**Subject: Beaver Valley Power Station, Unit No. 1
BV-1 Docket No. 50-334, License No. DPR-66
Response to Information Request Dated June 8, 1993
Spent Fuel Pool Rerack
(TAC No. M84673)**

This letter provides a response to your request for additional information regarding our proposed Technical Specification Change Request No. 202, submitted by letter dated November 2, 1992. These concerns are related to the seismic analyses that were performed to rerack the spent fuel pool. Attachment A provides each item followed by our response.

Beaver Valley Power Station, Unit No. 1
Response to Information Request Dated June 8, 1993
Spent Fuel Pool Rerack

FIGURE 1A

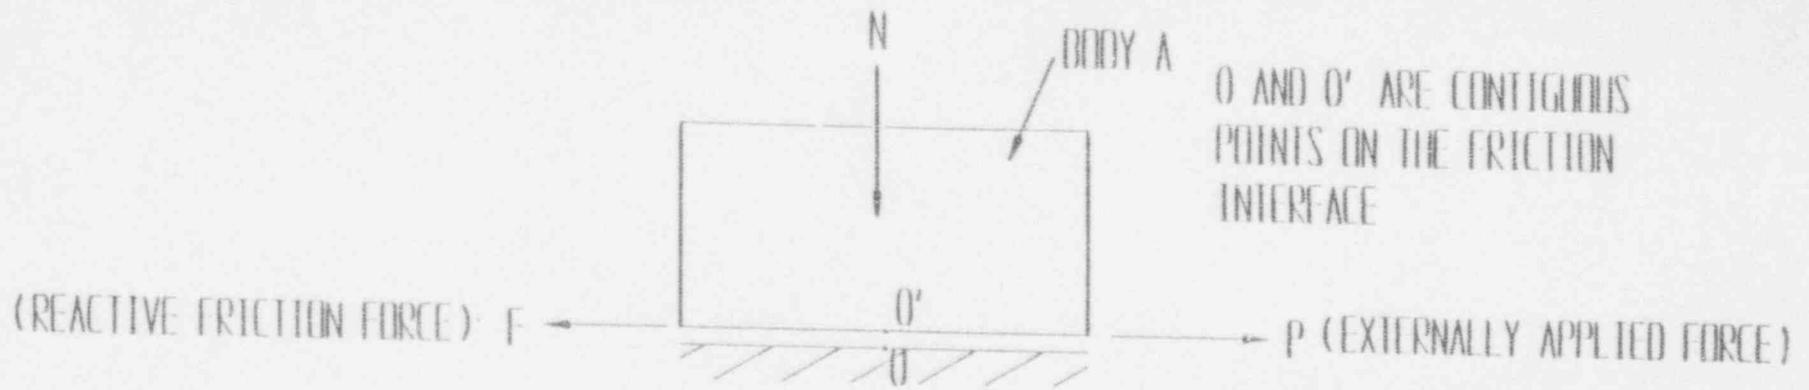
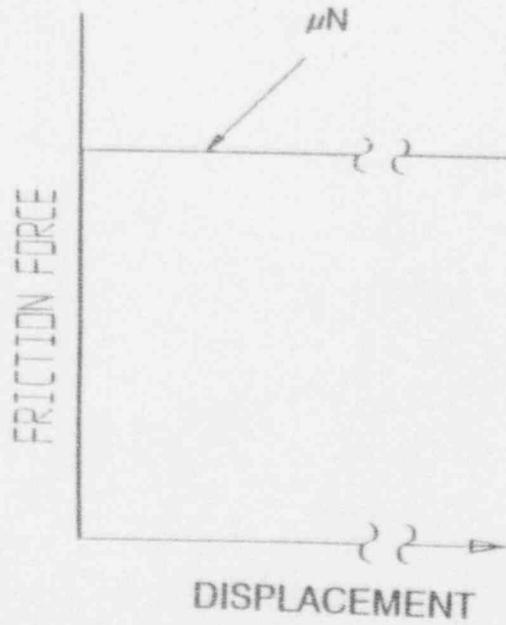
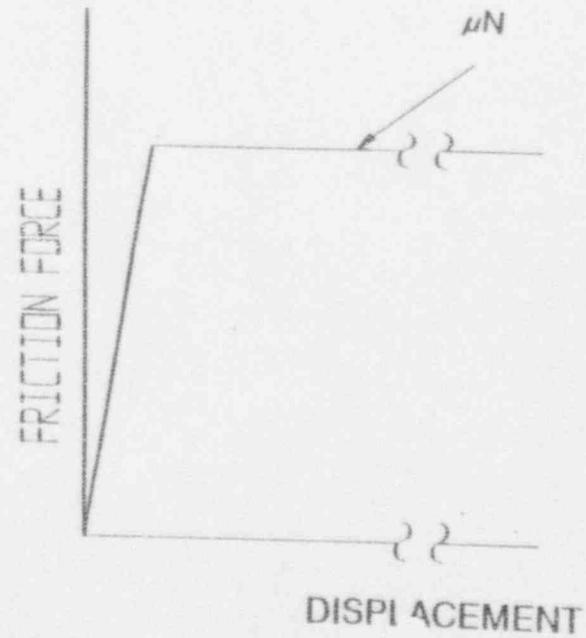
On page 6-9 it is stated that, "In the fuel rack simulations, the coulomb friction interface between rack support pedestal and liner is typical of a nonlinear spring." Please state the mathematical formulation of this nonlinear spring and describe the physical meaning of this formulation.

Coulomb friction force at a point is defined as:

It therefore follows for this simple example, that the body A subject to given interface load N, will begin to slide if the lateral load exceeds μN and the lateral displacement, δ , of body A will have the relationship depicted by Figure 1B, which can be written symbolically as:

The "ideal" Coulomb friction force-displacement profile shown in Figure 1B can be written in the more generalized form (refer to Figure 1C) as:

where K is the stiffness of the theoretical spring connecting point 0 and 0' at the interface in Figure 1A. Reference [6.4.4] of the submittal states that the spring constant, K, should be chosen an order of magnitude larger than the characteristic elastic stiffness of the interface structure.

FIGURE 2 HYDRODYNAMIC EFFECT BETWEEN TWO PLATES

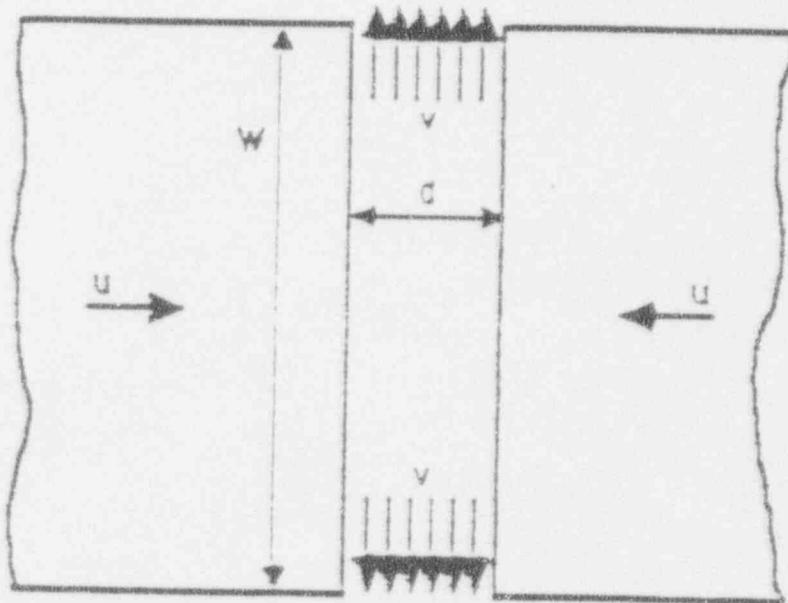
On page 6-11 it is stated that, "Fluid coupling between rack and fuel assemblies, and between rack and wall, is simulated by appropriate inertial coupling in the system kinetic energy." Provide sketches to indicate the physical model of the inertial coupling and describe how the model was represented mathematically.

To understand the nature of the forces arising due to hydrodynamic mass coupling, consider Figure 2 which shows two plates, forming a narrow fluid channel, approaching one another with speed u . The moving planes, for simplicity, are assumed infinitely long such that the motion of water exiting the inter-plane space remains in the plane of the paper. For this geometry, the average velocity of the exiting fluid v is computed by a direct volume balance. In the time interval Dt

The conclusion is that the speed of the water exiting the gap is W/d times the approach speed of the plane. In a typical maximum density spent fuel pool configuration, the ratio W/d is of the order 50-100. Since kinetic energy is proportional to the square of the speed, the water exiting the inter-rack space may have as much as 2500-10,000 times the specific kinetic energy of the rack. This hydraulic energy is either drawn from or added to the moving rack and modifies the rack submerged motion in a significant manner. In the maximum density configurations now in use, this effect cannot be neglected or approximated (note that for earlier low density rack configurations wide fluid gaps enabled arguments leading to consideration of the hydrodynamic effect only as it added mass to the rack). The above simple model illustrates the significance of hydrodynamic mass consideration in spent fuel rack seismic analyses.

FIGURE 6

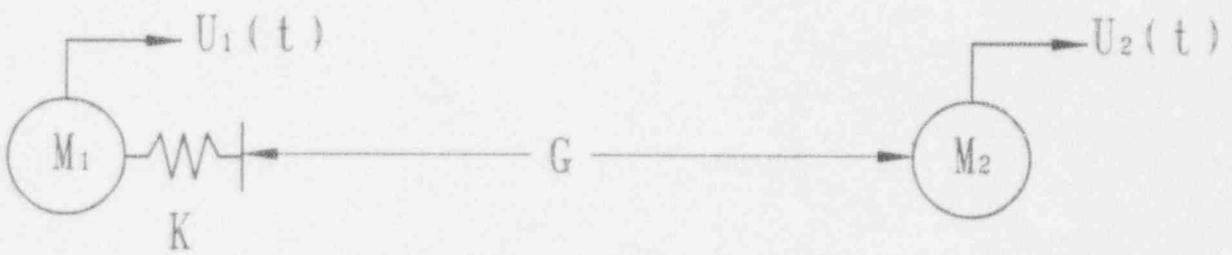
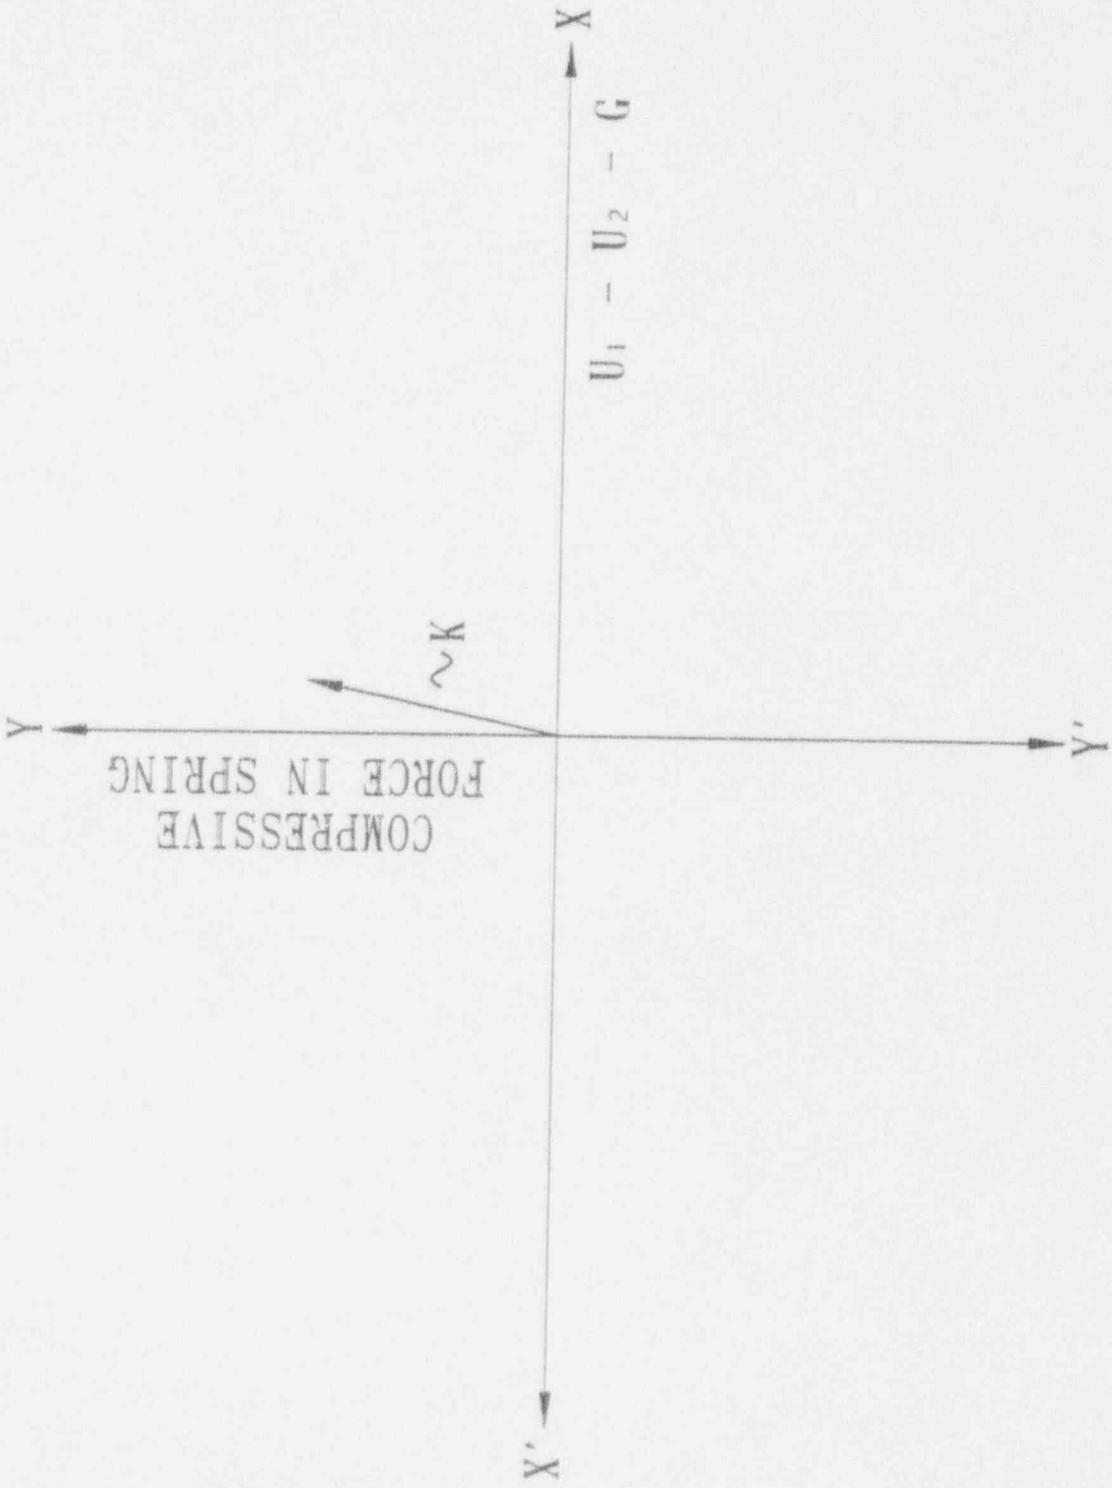
On page 6-11 it is stated that, "Potential impacts between rack and fuel assemblies are accounted for by appropriate compression-only gap elements between masses involved." Please illustrate how the gap elements actually accounts for the potential impacts between the rack and fuel assemblies (use sketches and description).

Figure 6 shows two masses separated by a compression-only gap element. G is the initial gap, ≥ 0 , between the two masses. The mass motion is described by variables $U_1(t)$ and $U_2(t)$. The spring constant K reflects the local stiffness between the two masses. Figure 7 shows the force deflection relationship for the compression-only gap element. During the motion, if $U_1 - U_2$ is less than the initial gap prescribed, the masses are not in contact and the force in the gap element is zero. If the gap closes, then $U_1 - U_2 - G > 0$, and a force builds up in accordance with the local stiffness K . When the gap opens, at some other time, then the force drops to zero. In DYNARACK, the status of each gap element is checked at each instant during the solution, and the equilibrium equations updated to reflect open or closed gaps.

FIGURE - 8A DYNARACK NONLINEAR ELEMENTS
 (ELEMENT NUMBERS REFER TO TABLE IN SUBMITTAL)

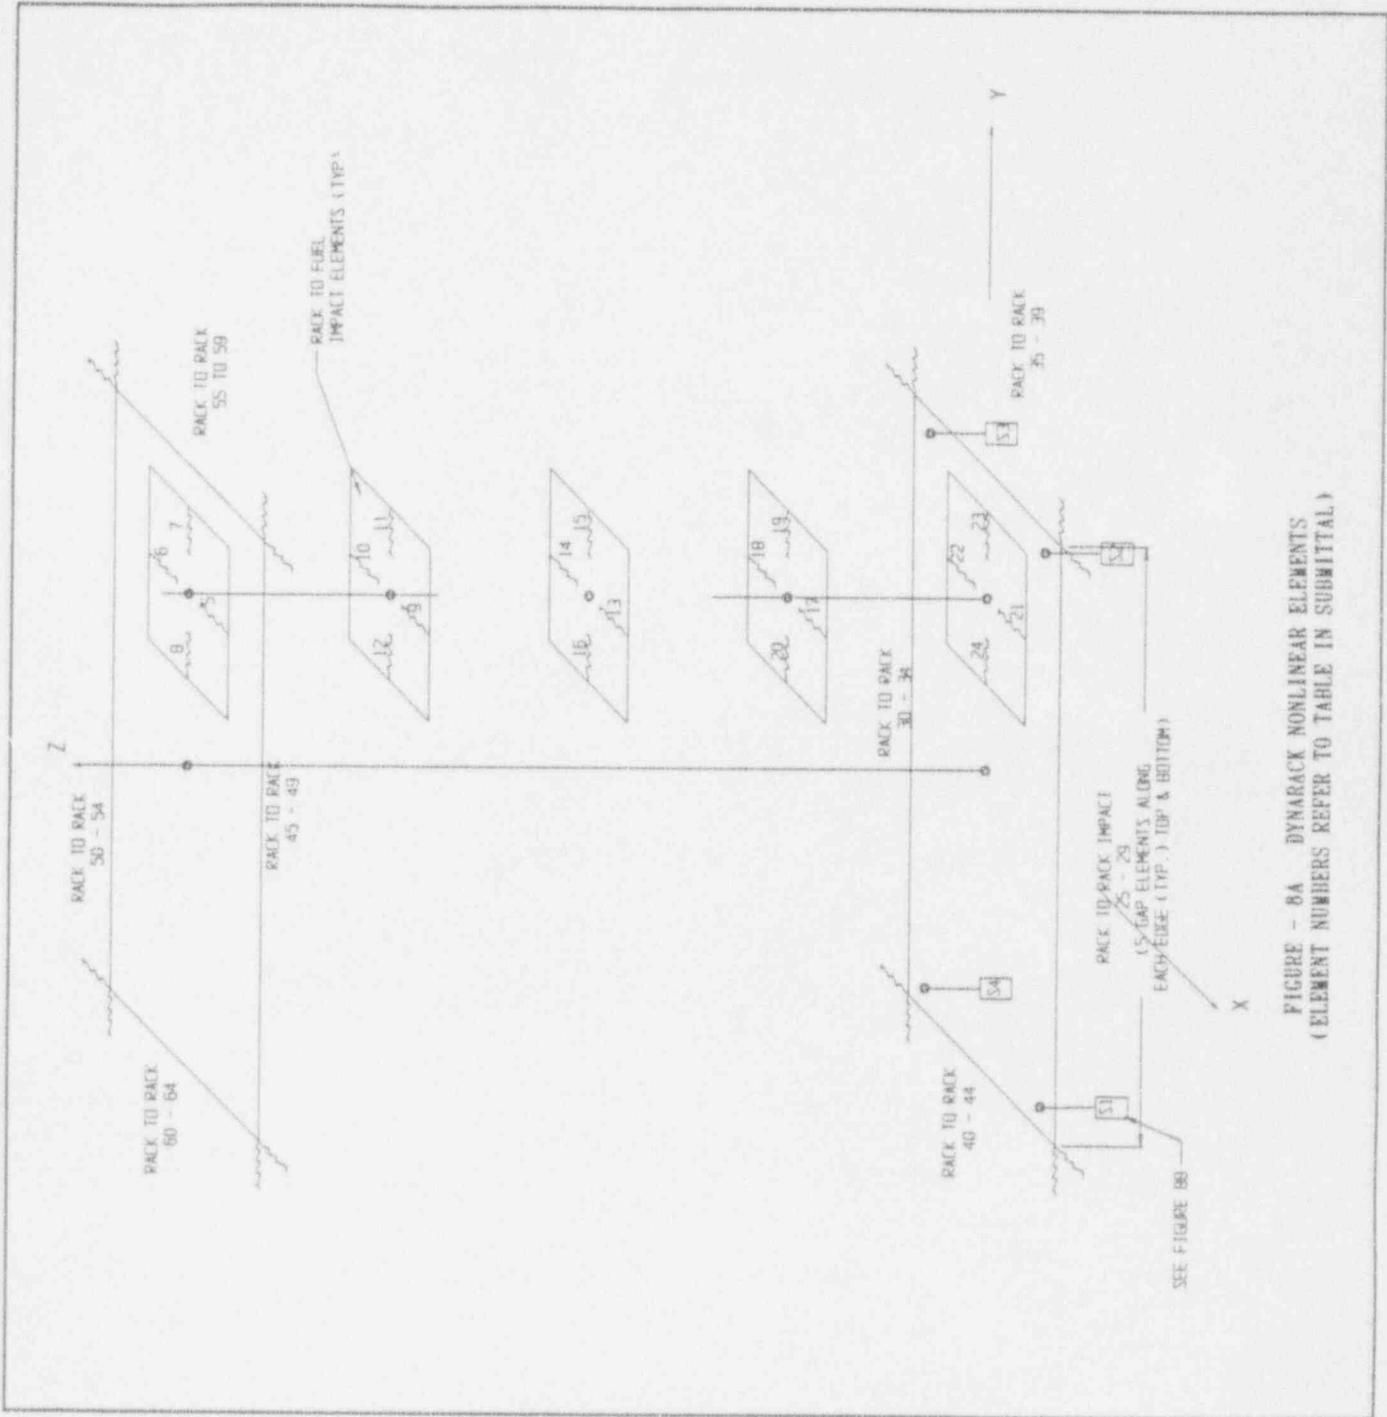
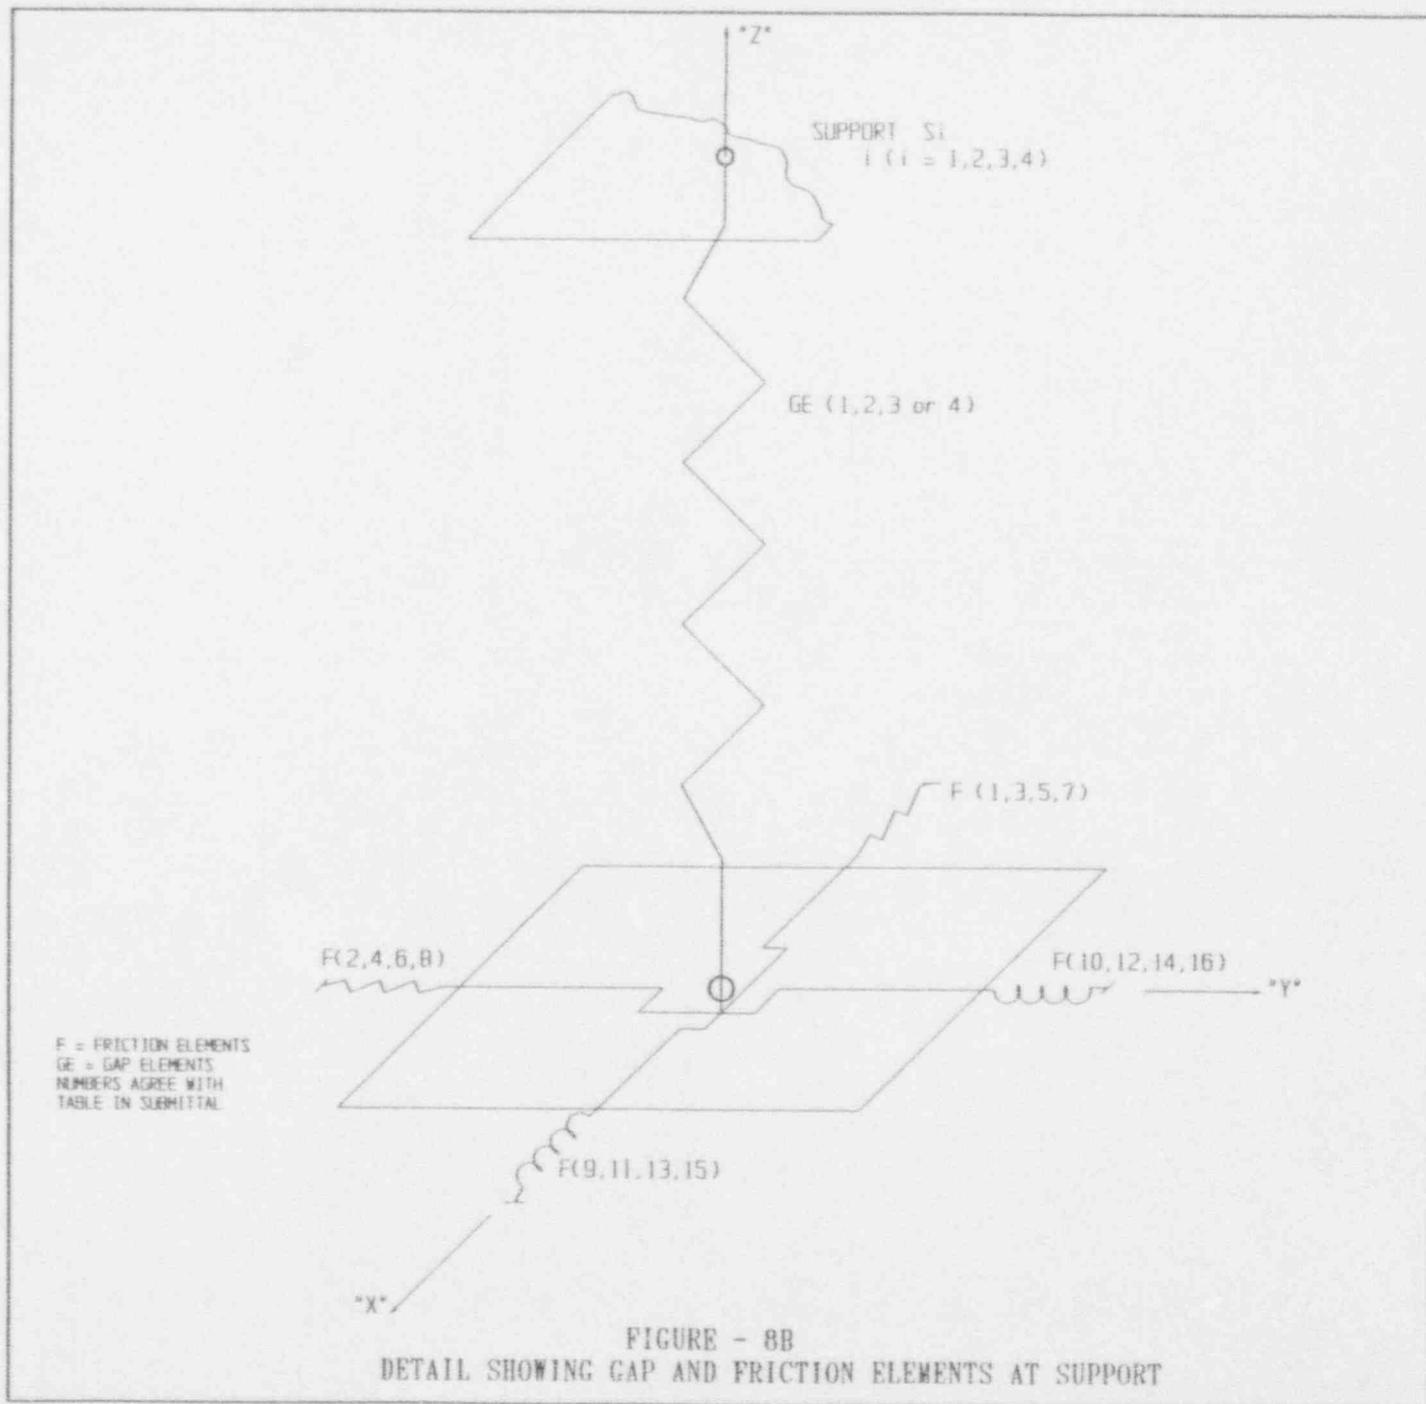
Table 6.4.2 contains numbering system for gap elements and friction elements. Provide a drawing of the model that shows the gap and friction elements as stated in Table 6.4.2.

Figures 8A and 8B provide multiple view drawings for clarity.
